Multi-Building Mixed-Use Height and Setback Profile

Ordinance as written
with wrong interpretation
of P&Z recs

Mixed-Use Height & Setback Overlay Profile

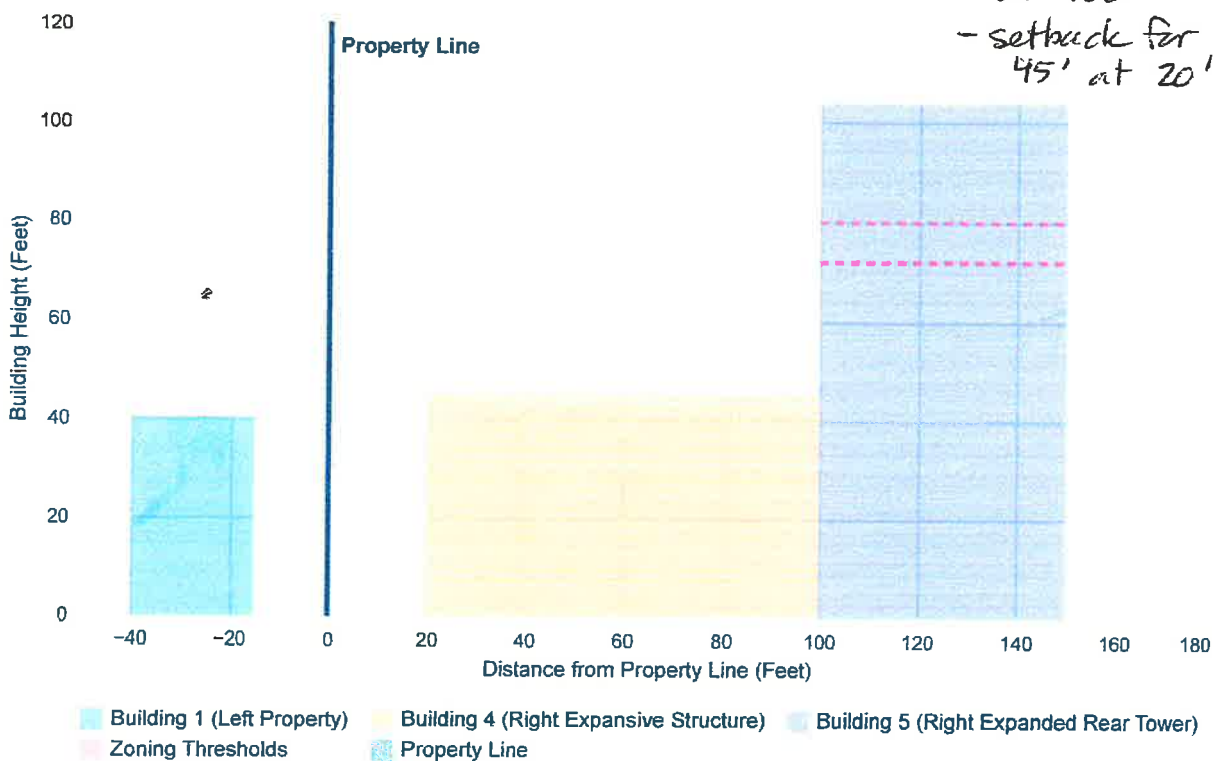
Ordinance as written for recs from P & Z
Correct Interpretation either 45' or 72' can be built depending on setback from property line

But not both 45' and 72' next to WFD

- setback for 72+ bldg at 100'
- setback for 45' at 20'
